## 675 Moffat SRU – Review #1

**Re:** SRU-001567-2023 675 Moffat SRU

### DRT Review Comments

**Hull Duplex**  
675 Moffat St  
Erie, Colorado 80516

1 SITE PLAN - PROPOSED  
1" = 20'-0"

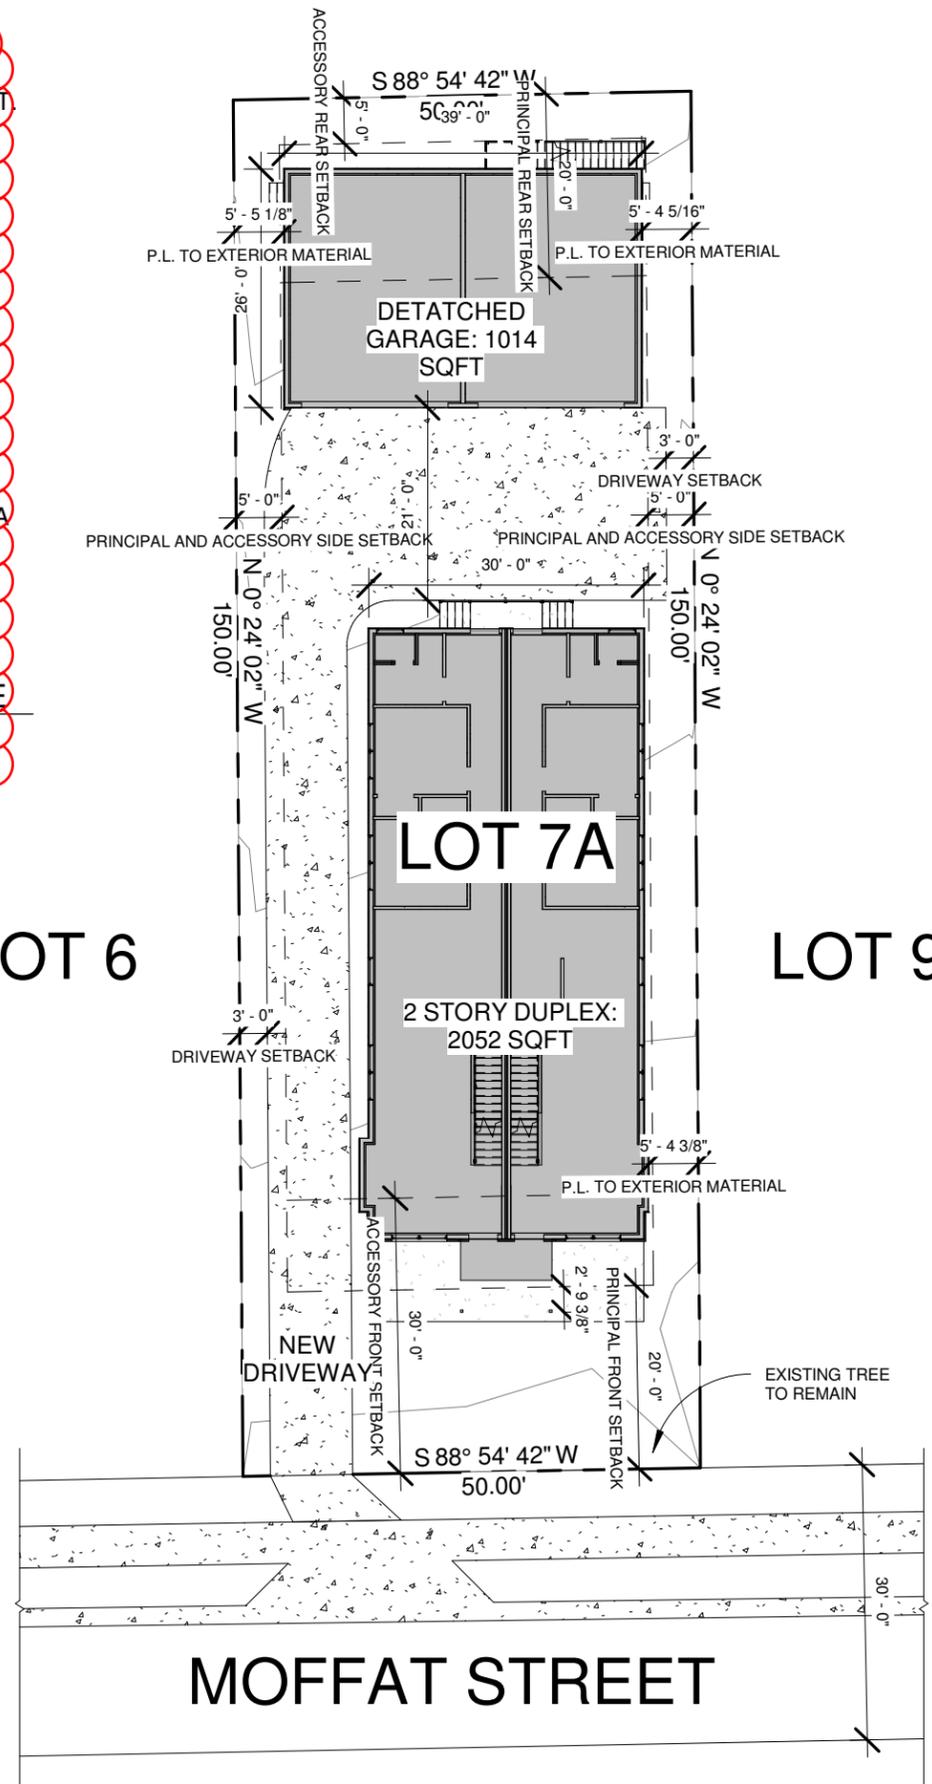
Please add the Narrative from Sheet 2

Exhibit showing the site plan in relation to surrounding context (adjacent properties)

Consider using the above chart to demonstrate how the project will comply with landscaping requirements. Alternatively, a landscaping plan could be provided instead or in addition to this chart.

PROJECT NARRATIVE

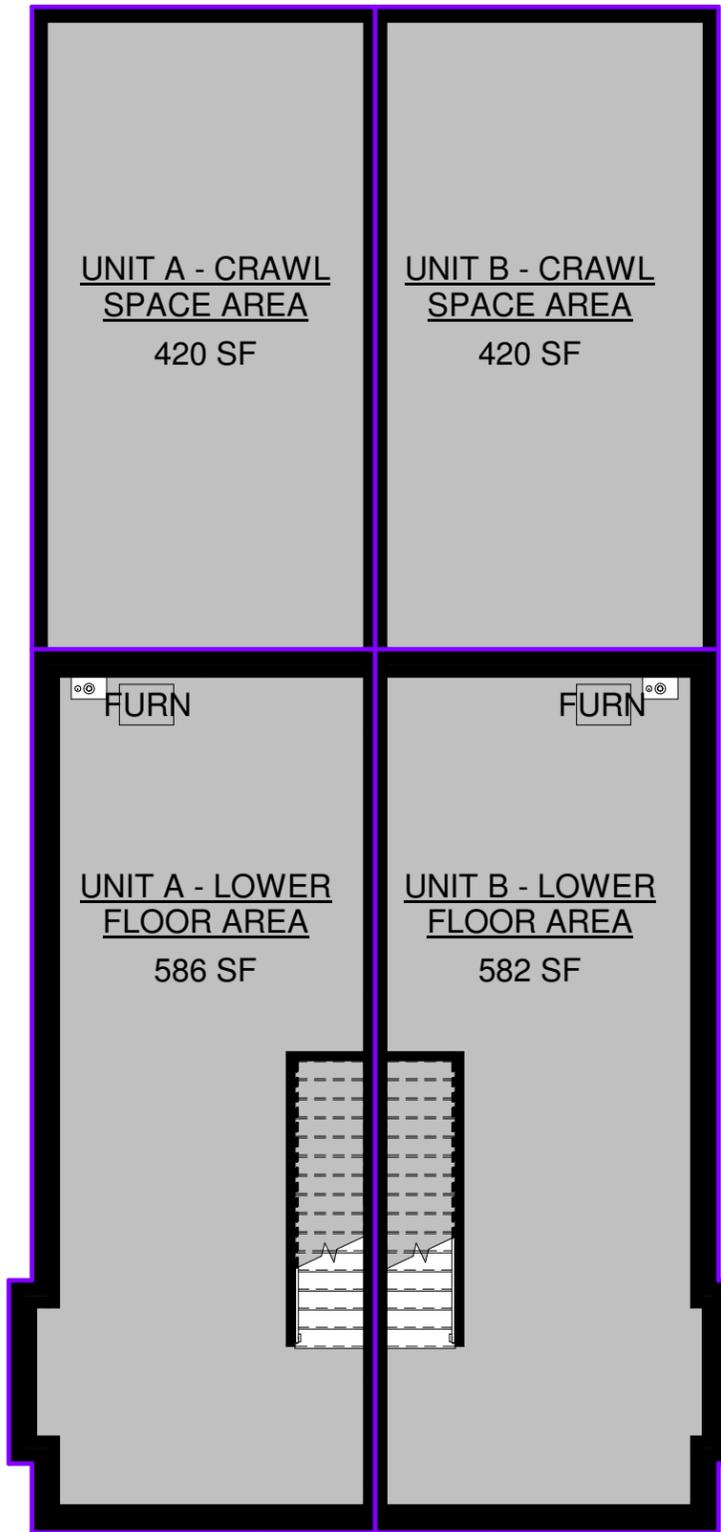
Please move narrative to new cover sheet
